**MINERALS PROGRAM INSPECTION REPORT**  
**PHONE: (303) 866-3567**

<b>MINE NAME:</b> Cresson Project	<b>MINE/PROSPECTING ID#:</b> M-1980-244	<b>MINERAL:</b> Gold and silver	<b>COUNTY:</b> Teller
<b>INSPECTION TYPE:</b> Monitoring	<b>WEATHER:</b> Windy	<b>INSP. DATE:</b> May 28, 2025	<b>INSP. TIME:</b> 09:30
<b>OPERATOR:</b> Cripple Creek & Victor Gold Mining Company	<b>OPERATOR REPRESENTATIVE:</b> Brian Doering	<b>TYPE OF OPERATION:</b> 112d-3 - Designated Mining Operation	
<b>REASON FOR INSPECTION:</b> Normal I&E Program	<b>BOND CALCULATION TYPE:</b> None	<b>BOND AMOUNT:</b> \$319,158,980.00	
<b>DATE OF COMPLAINT:</b> NA	<b>POST INSP. CONTACTS:</b> None	<b>JOINT INSP. AGENCY:</b> None	
<b>INSPECTOR(S):</b> Hunter Ridley Ben Hammar	<b>INSPECTOR'S SIGNATURE:</b> 	<b>SIGNATURE DATE:</b> June 18, 2025

**Re: Permit No. M-1980-244; Cripple Creek & Victor Gold Mining Company; Cresson Project; –  
May 28, 2025, Inspection Follow-Up**

### Schist 2 Backfill Overview May 29, 2025

## Attachment 1

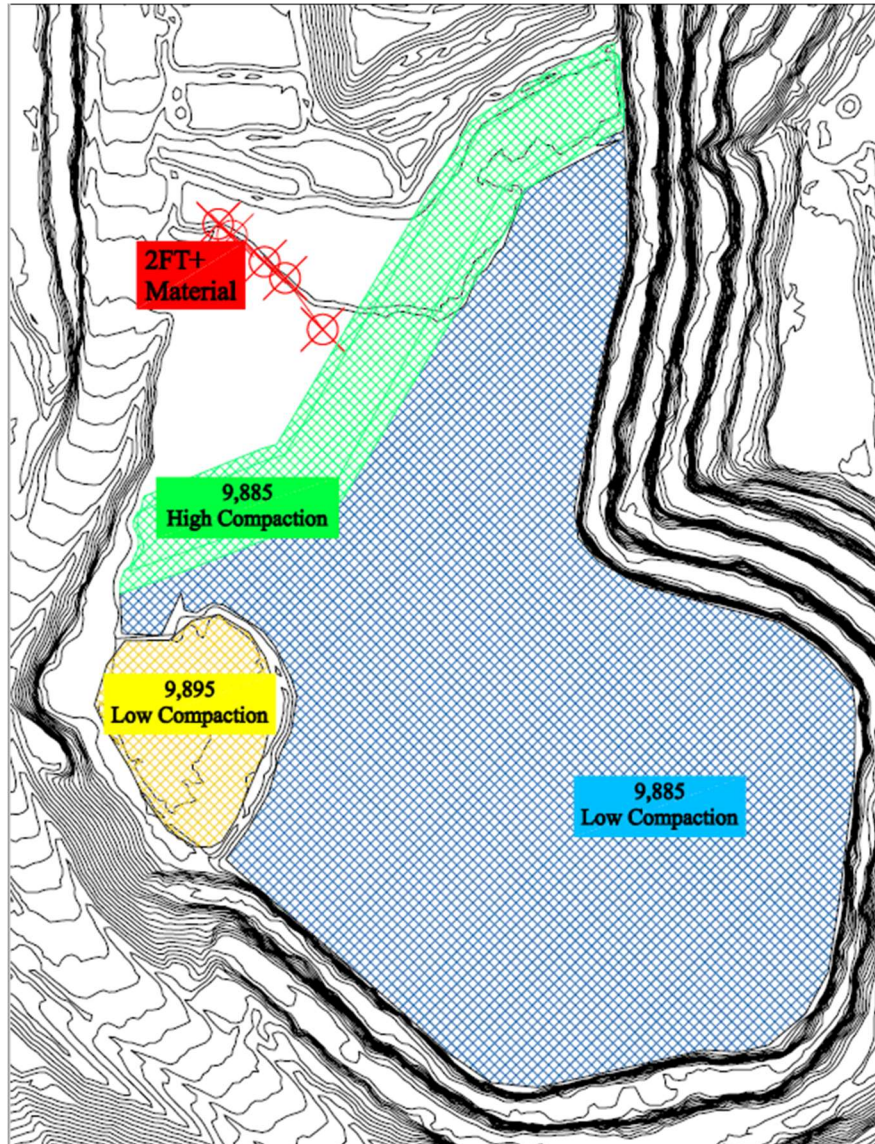
The Division then walked north in the backfill area to inspect the high compaction zone. While CC&V currently conducts their own quality control for the low compaction zone, NewFields is in charge of quality control for the high compaction zone. Tyler, with NewFields, reconfirmed that each 5 foot lift is signed off by one of their staff before the next lift begins. The Division noted that there were many pieces of material in this area that appeared to be slightly or well above the 2 foot maximum specification limit for the high compaction zone. Therefore, the Division inspected the entire length of the northern face (Photo 4), documenting the size of ~8 large boulders. These are shown in Photos 3 through 12. About  $\frac{3}{4}$  of this northern face contained material that is compliant with the high compaction specifications. At the western end is where the Division found a collection of larger boulders (Photo 12). NewFields could not determine in the field whether or not the large boulders observed were in or outside of the official line for the high compaction zone. The Division asked that Mr. Doering confirm this with a survey and provide the Division with the updated information. If the material observed *was* in the high compaction zone, the Division informed CC&V representatives that they would need to remove such material prior to dumping the next lift. The Division received an email from Mr. Doering on June 5, 2025. The report provided is attached below and shows that the large boulders observed were *not* within the high compaction zone.

**Photo 12: View southwest of the dump face where large rocks were observed and measured. In general, this area holds many larger rock fragments that are likely not within high compaction specifications.**

- 1. Confirm whether or not 2ft+ boulders were within the high compaction zone.**
  - a. The 2ft+ boulders identified during the inspection were surveyed for their precise location. The surveyed locations were compared to the zone of high compaction, and shown to be outside of that zone.*
  - b. **Attachment 1** identifies the boulder locations as well as the high and low compaction zones for the relevant lift elevations.*
- 2. If 2ft+ boulders are within the high compaction zone, remove them from the zone and document the process.**
  - a. Because the 2ft+ boulders were outside of the low and high compaction zones, the boulders were not removed.*

The blue and yellow areas highlight the current low compaction lifts. Green highlights the high compaction zone including the 9,875 to the 9,885 elevations. The > 2ft boulders identified during the May 28<sup>th</sup> inspection were surveyed and are identified with the red icons, outside both the high and low compaction zones.
